STAFF REPORT
(Final Plat)

CASE NUMBER: S/D 93-24 - REPLAT OF WEST LAKEWOOD ESTATES
ADDITION FINAL PLAT

Review Dams - West Lakewood Estates

West Lakewood Estates

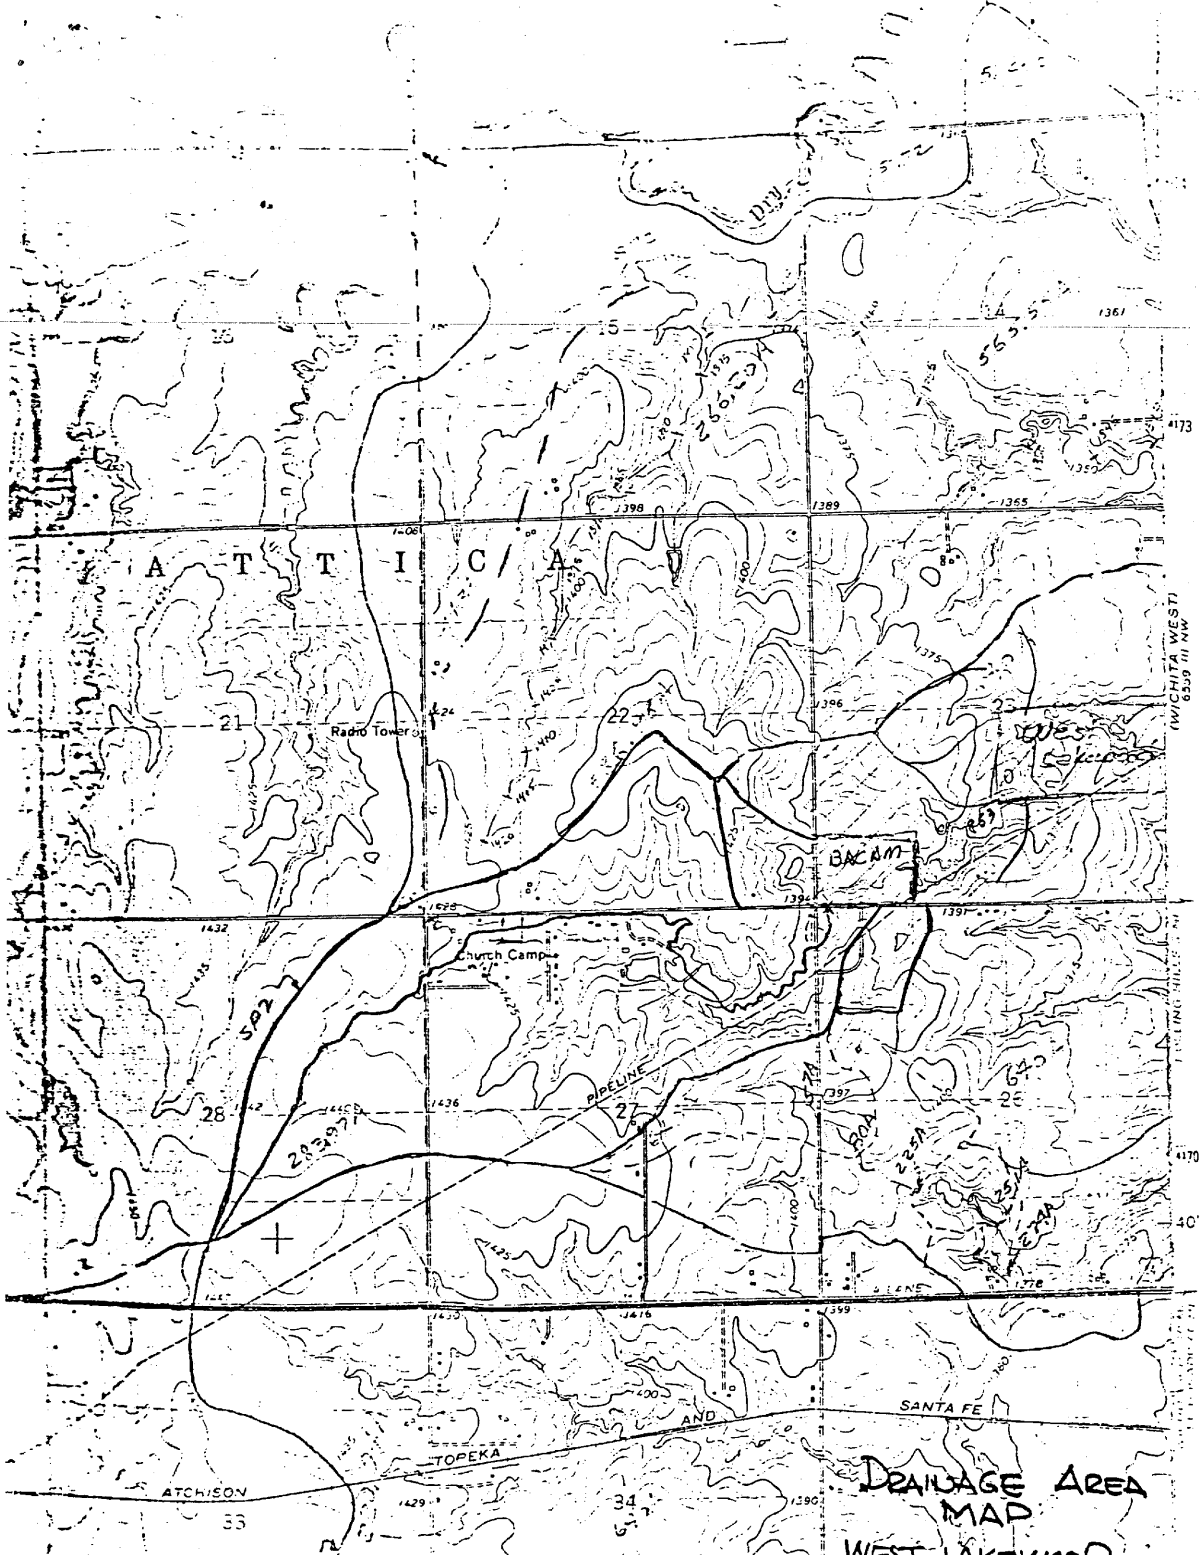
We concur with K.O. Taylor on his Drainage Area of 1050 Acres and 100yr Discharge of 1680 cfs. The 160 foot wide weir at spillway elevation of 1346.3 produces a water surface of 1348.47, we approve his 1349.0. This would then establish a top of dam of 1352' which is proposed. This would also establish a minimum bed of 1352' on any development fronting on the lake.
